AMENDED PROPOSED

SEPTIC SYSTEM PLAN

LOCUS: ATLANTIC AVENUE NORTH HAMPTON, NH

* AMENDED 8/20/91

PLAN : 1"=20'

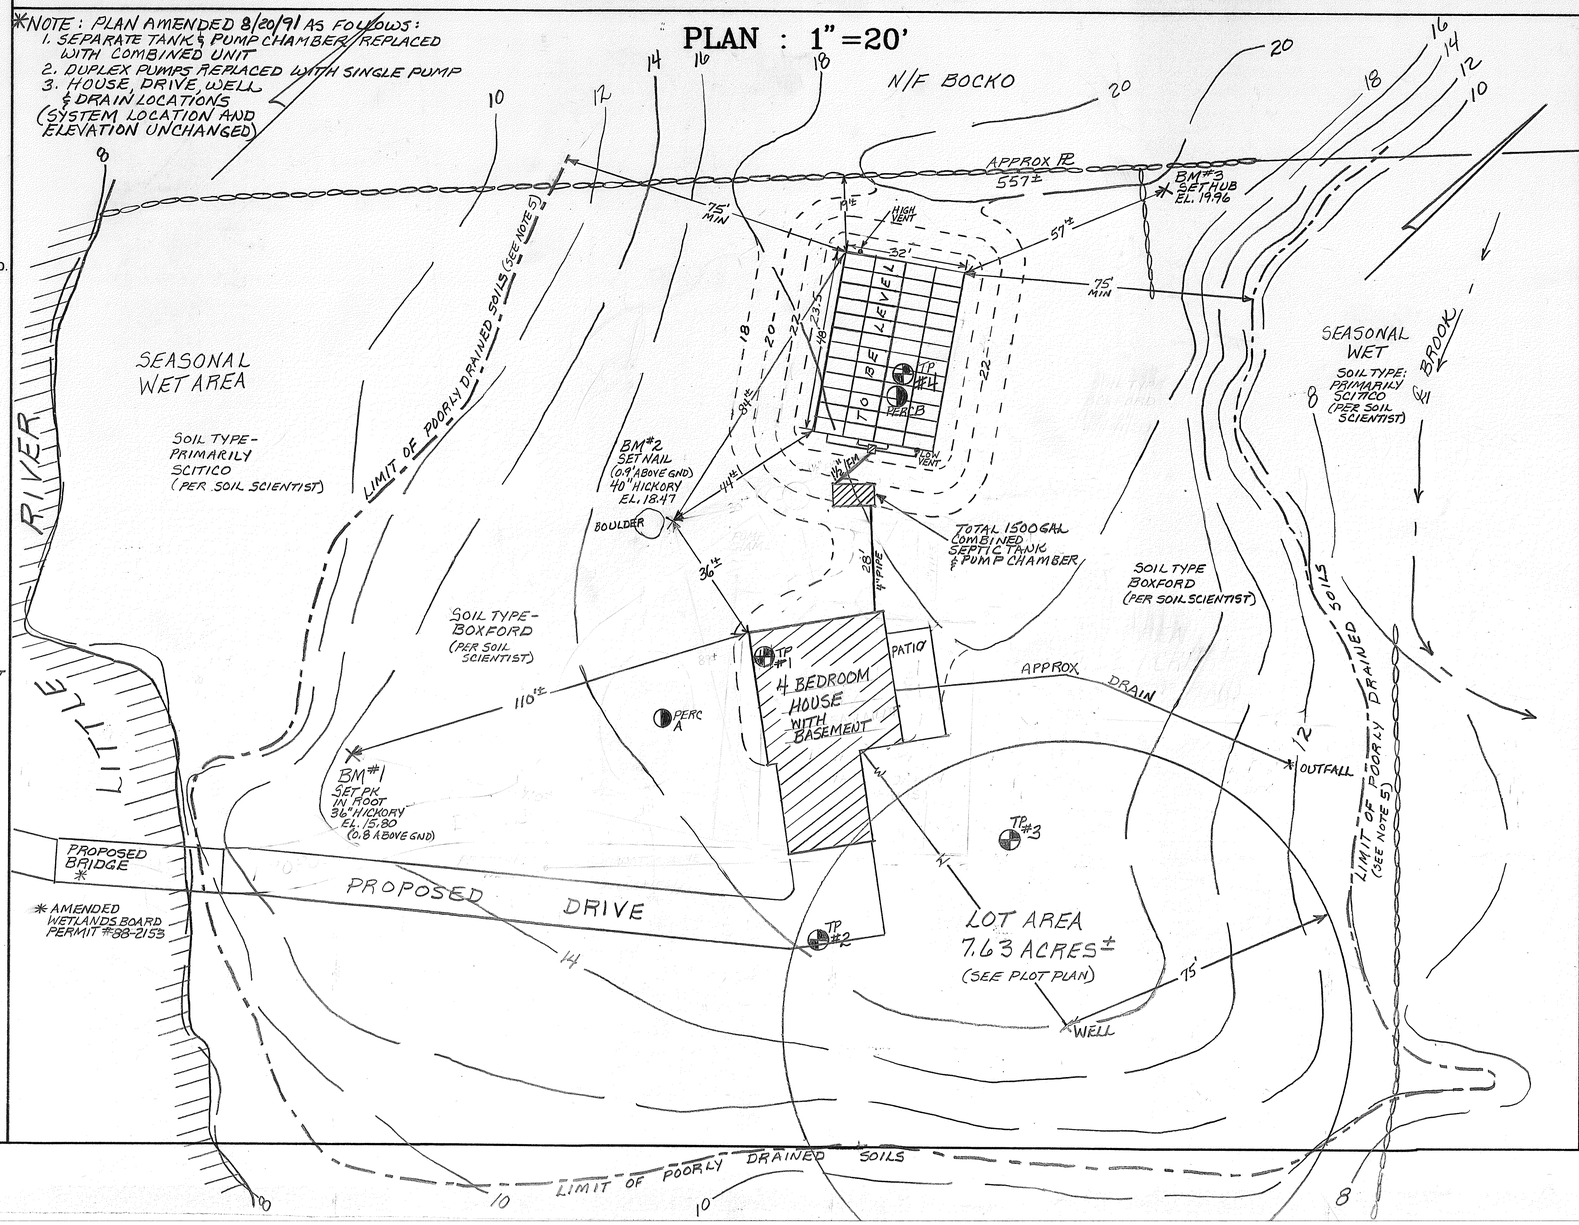
*NOTE: PLAN AMENDED 8/20/91 AS FOLLOWS:
1. SEPARATE TANK & PUMP CHAMBER REPLACED WITH COMBINED UNIT
2. DUPLEX PUMPS REPLACED WITH SINGLE PUMP
3. HOUSE, DRIVE, WELL & DRAIN LOCATIONS (SYSTEM LOCATION AND ELEVATION UNCHANGED)
